Contract #: 04-0120F4Cty: SF/ALA Rte: 80 PM: 13.2/13.9File #: 69.25B**QUALITY ASSURANCE -- NON-CONFORMANCE REPORT****Location:** Changxing Island, Shanghai, China**Report No:** NCR-000972**Prime Contractor:** American Bridge/Fluor Enterprises, a JV**Date:** 19-Jan-2011**Submitting Contractor:** Zhenhua Port Machinery Company, Ltd (ZPMC), Changxing Island**NCR #:** ZPMC-0931**Type of problem:**

**Reference Description:** Missed Class "A" (UT) Indications on Lift 14W weld numbers SEG3020Q-058 and SEG3020K-026 discovered by QA

**Dear:** Mr. Charles Kanapicki  
**Job Name:** SAS Superstructure

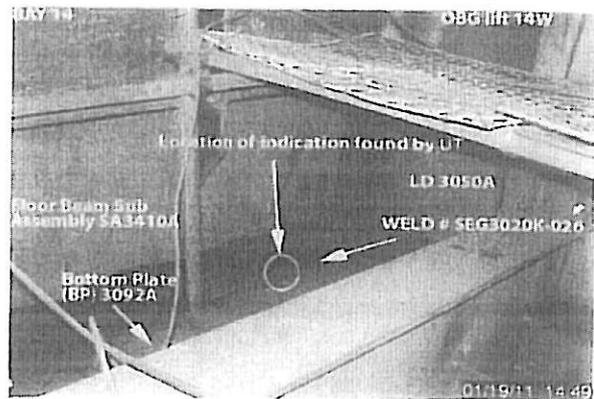
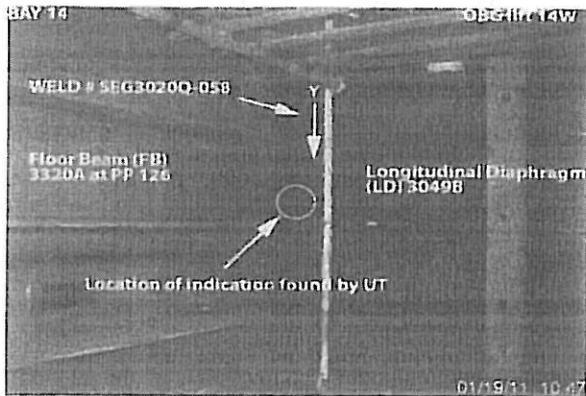
- One Class "A" longitudinal indication measuring approximately 20mm in length.
- The depth of the indication is 21mm from face A.
- The db rating is +4.
- The material thickness is 30mm.
- The weld is identified as: SEG3020Q-058.
- The Weld is a Complete Joint Penetration (CJP), Tee-joint, joining the Floorbeam (FB3320A) to the Longitudinal Diaphragm (LD3049A) at Panel Point (PP126).
- The "Y" location of the indication is 1575mm from the top end of the weld as shown in the attached photograph.
- The indication is clearly marked on the component.
- The material is identified as Seismic Performance Critical Member (SPCM) and the weld is identified as Fracture Critical Weld (FCW).
- The member is located in Bay 14.

- One Class "A" longitudinal indication measuring approximately 20mm in length.
- The depth of the indication is 23mm from face A.
- The db rating is +6.
- The material thickness is 25mm.
- The weld is identified as: SEG3020K-026.
- The Weld is a Complete Joint Penetration (CJP), Tee-joint, joining the Floor Beam Sub Assembly (SA3410A) to the Bottom Plate (BP3092A) at Panel point (PP127.3).

- The "Y" location of the indication is 450mm from the Longitudinal Diaphragm (LD3050A) as shown in the attached photograph.
- The indication is clearly marked on the component.
- The material is identified as Seismic Performance Critical Member (SPCM) and the weld is identified as Fracture Critical Weld (FCW).
- The member is located in Bay 14.

The Notice of Witness Inspection Number (NWIT) is 08220. The indication is located inside the area that has been previously tested and accepted by ZPMC Quality Control (QC) personnel. As per the contract documents, ZPMC's QC personnel are required to perform 100% UT inspection of these welds. Attached photographs provide additional location details.

Contractor will repair the welds, and provide the NDT report to prove the weld is acceptable. Contractor will identify and monitor the inspector responsible. Disciplinary action will be undertaken if the inspector continues missing indications.

Contractor repaired the indications. NDT report was provided which shows the welds are acceptable. Contractor identified the inspector responsible and his performance is being monitored
